CITY OF ALBUQUERQUE

RE: 9808 Davenport NW **Request for Pad Certification – Not Accepted Engineer's Stamp Date 7/17/18 Certification Dated: 8/8/18** Hydrology File: B13D011A

CER Ŧ **CATION**

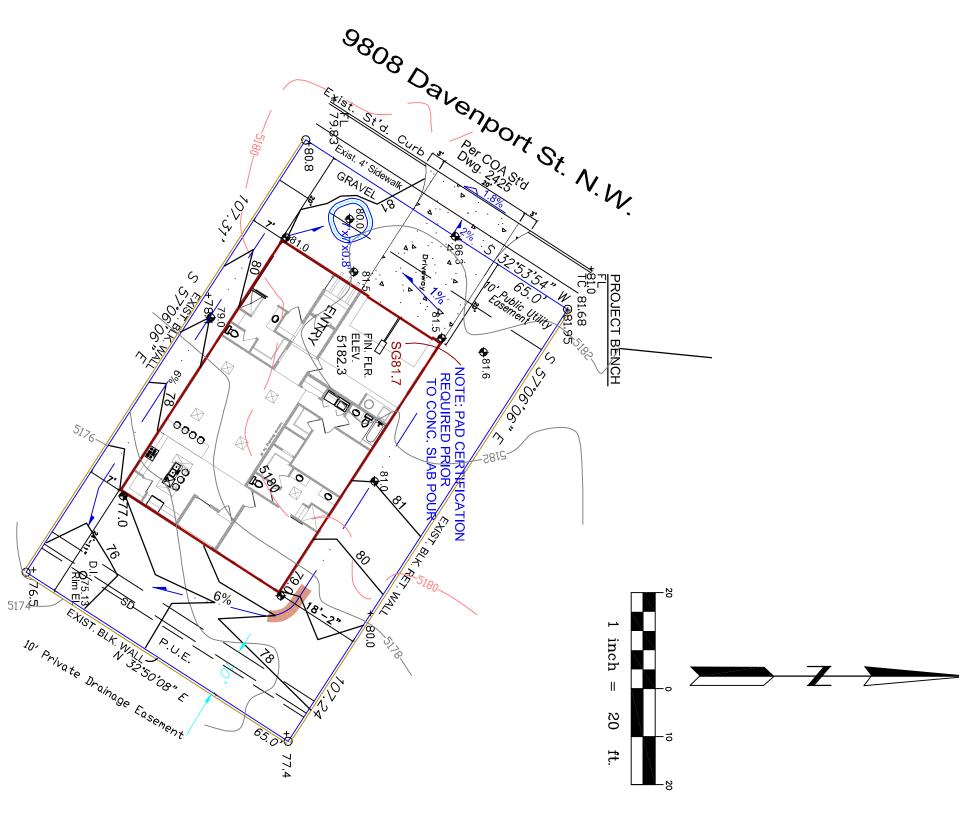
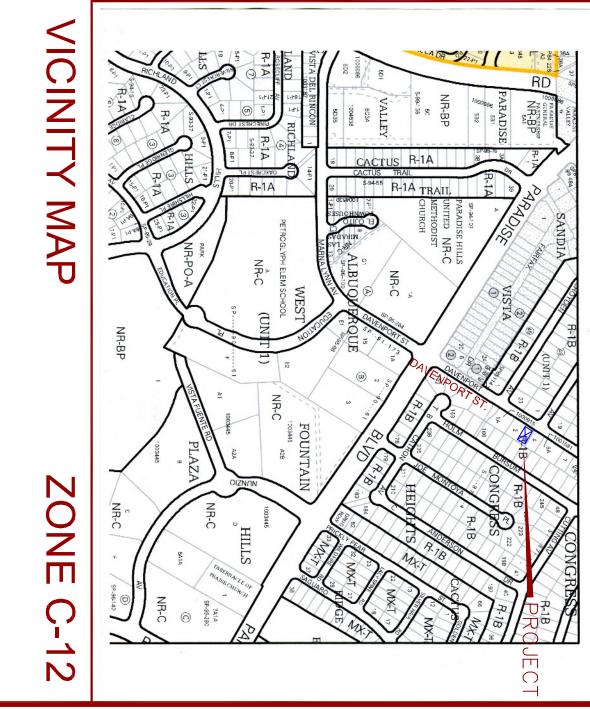
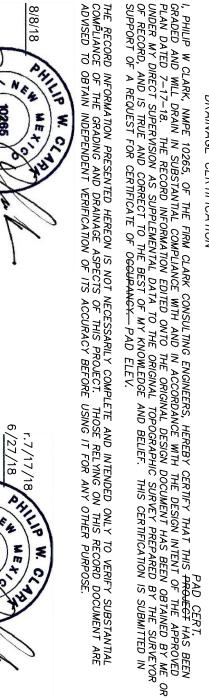
- 1. Remove dirt from neighboring wall on the south side.
- 2. Prepare the subgrade for the stemwall NM 87103

3. Engineer's Certification, per the DPM Chapter 22.7: Engineer's Certification Checklist For www.cabq.gov Non-Subdivision is required to ensure the site and the grades against the neighboring walls were not disturbed during home construction.
